**Comments of the
American Automobile Manufacturers Association
on the California Air Resources Board (CARB)
Notice of Public Hearing
to Consider Technical Status and Proposed Revisions
to Malfunction and Diagnostic System Requirements
for 1994 Model-Year Passenger Cars, Light-Duty Trucks,
and Medium Duty Vehicles and Engines (OBD II)**

CONCERNING ON-BOARD DIAGNOSTIC II (OBD II) REQUIREMENTS

**GENERAL MOTORS STATEMENT TO THE
CALIFORNIA AIR RESOURCES BOARD (CARB)
REGARDING PROPOSED REVISIONS TO THE
ON-BOARD DIAGNOSTIC REQUIREMENTS (OBD-II)**

Figure 1

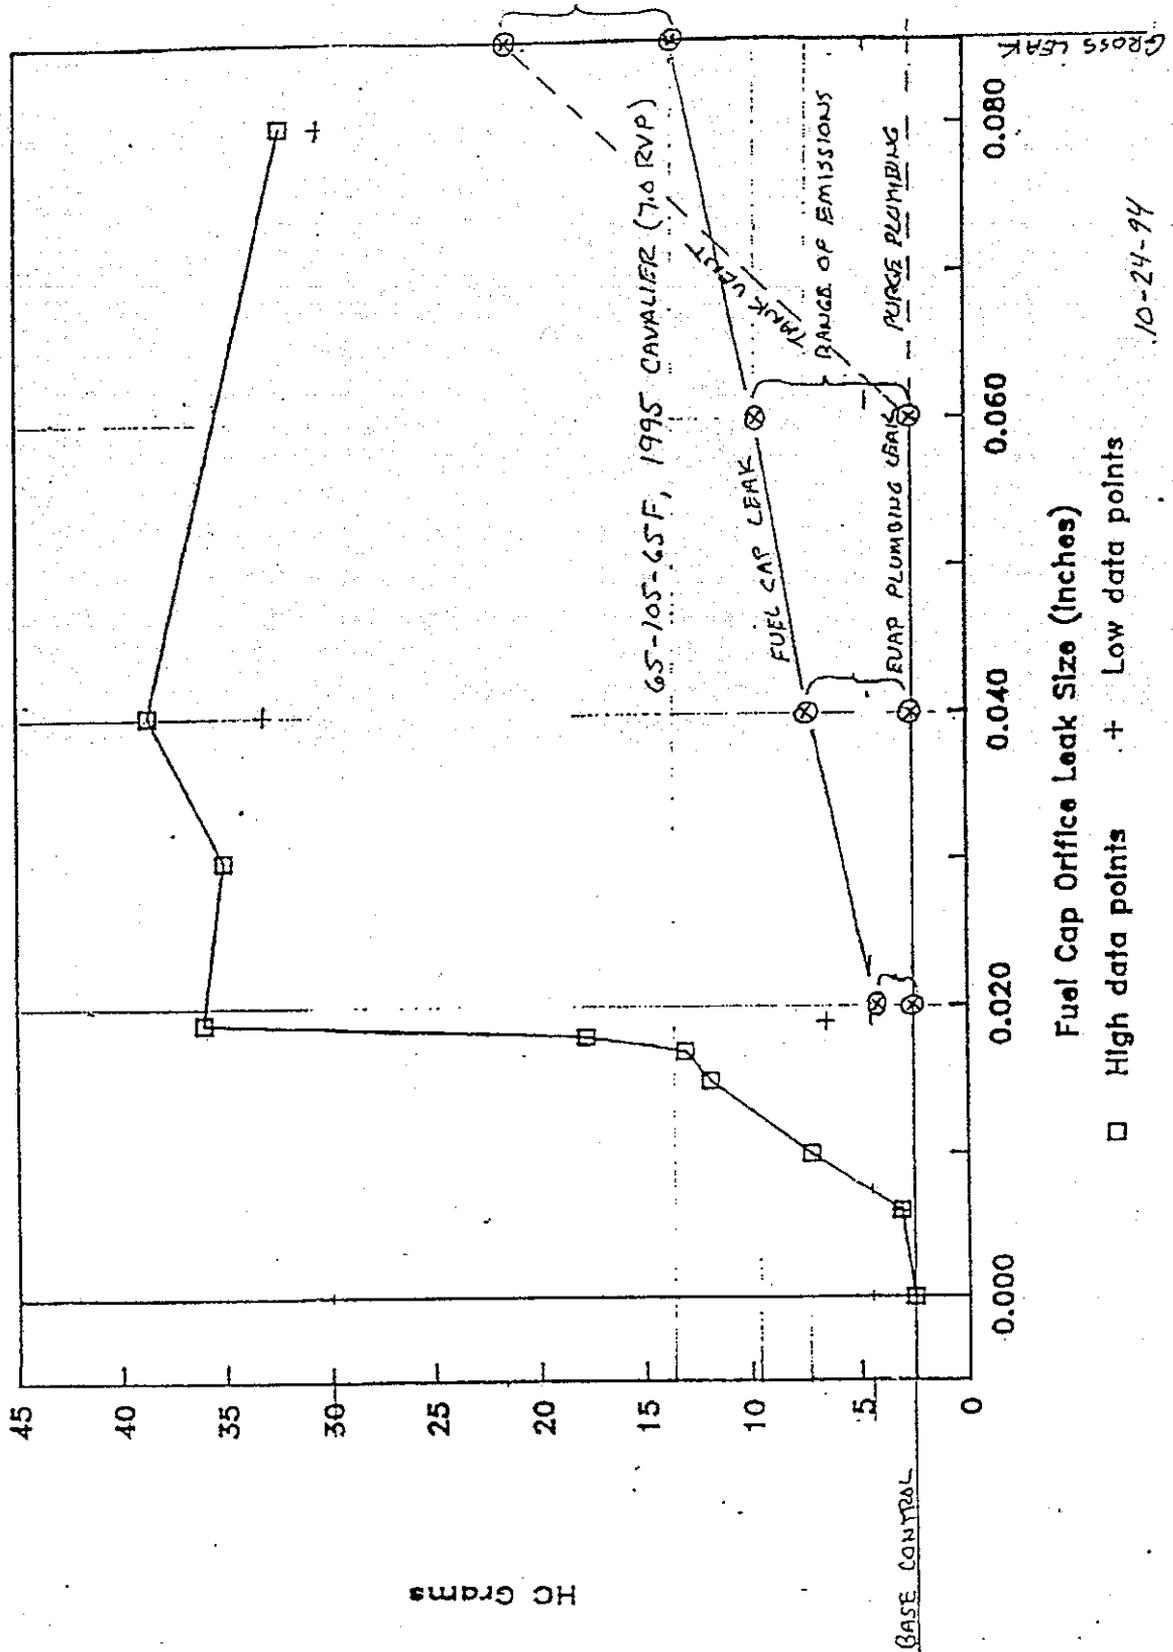
Evaporative System Monitoring: The staff has proposed to revise section (b)(4.0) to require detection of 0.020 inch leaks beginning with the 1998 model year with a phase-in of 50/75/100 percent of evaporative families. The justification for the increase in stringency was that there could be significant further emission reductions by reducing the size of leak to be detected. This emissions reduction conclusion is based, in part, upon data generated by GM using a 1990 Buick Regal.

GM believes that the staff is overestimating the significance of the contribution of small leaks (between 0.020 and 0.040 inch) to in-use emissions for many reasons. The data from the CARB surveillance programs, which the staff used as evidence that 0.020 inch leaks occur frequently in-use, was not collected under sufficiently controlled conditions to give accurate results. (While the CARB staff recently investigated the effects of fuel cool down, their study did not reflect the high temperatures reached at the tops of metal fuel tanks because of exhaust system heating, etc., and the subsequent effect of rapid cool down on the pressure of the vapor space.) Furthermore, no attempt was made to find small leaks and determine the area of the leak opening in the surveillance programs. Since the pressure data are suspect and no small leaks were actually identified, the staff has not demonstrated that leaks between 0.020 and 0.040 inch exist in significant numbers in the field. After analyzing the in-use data which has been collected by CARB, EPA, and GM, we have concluded that the percent of in-use vehicles with leaks between 0.020 and 0.040 inch is much lower than the CARB staff's estimate of 7.8 percent.

More importantly, radically improved designs needed to meet both the enhanced evaporative and Federal On-board Refueling Vapor Recovery requirements have reduced the resistance of vapor flowing to the canister which has dramatically reduced the potential emissions resulting from small leaks. The previous data we submitted for a 1990 vehicle are no longer applicable. As illustrated in Figure 1, the emissions from a 0.020 inch leak on a 1995 Cavalier with 7.0 RVP fuel are expected to range from negligible to 3 grams HC depending on leak location. Average emissions from 0.020 inch leaks would be much less than 3 grams HC. This is a dramatic reduction from what was observed on a 1990 vehicle. Recent data generated by another manufacturer supports this trend, showing emissions from a 0.020 inch leak that are less than 0.2 grams HC.

Therefore, GM recommends the following:

1. A government/industry study to identify and quantify evaporative system leaks in the real world and evaluate their emissions impact.
2. Allow time for the current evaporative system diagnostics to mature in the field. We are concerned that the service community may not be able to verify, locate, and repair small leaks. This will require proper training, tools, and some real world experience. Changing the diagnostic strategy after only 1 or 2 years in the field may create much confusion if new detection tools and methods need to be implemented.
3. Have a CARB workshop during calendar year 1998 to review the following:
 - Field results with the 0.040 inch leak detection systems
 - Proposed OBD strategies to detect 0.020 inch leaks
 - Potential real world emissions impact of 0.020 inch threshold
 - Ability of service industry to find & repair leaks smaller than 0.020 inch

The CARB should delay requiring a 0.020 inch threshold until it is demonstrated to be cost effective and until it has been demonstrated that it is feasible to find and repair leaks smaller than 0.020 inch. If this can be demonstrated, the 0.020 inch threshold should be phased-in, starting no sooner than the 2001 model year, to allow sufficient lead time for new diagnostic systems/hardware. If the CARB elects not to delay the phase-in, GM would prefer that the phase-in be modified to coincide with the phase-in of the Federal on-board refueling vapor recovery requirements.
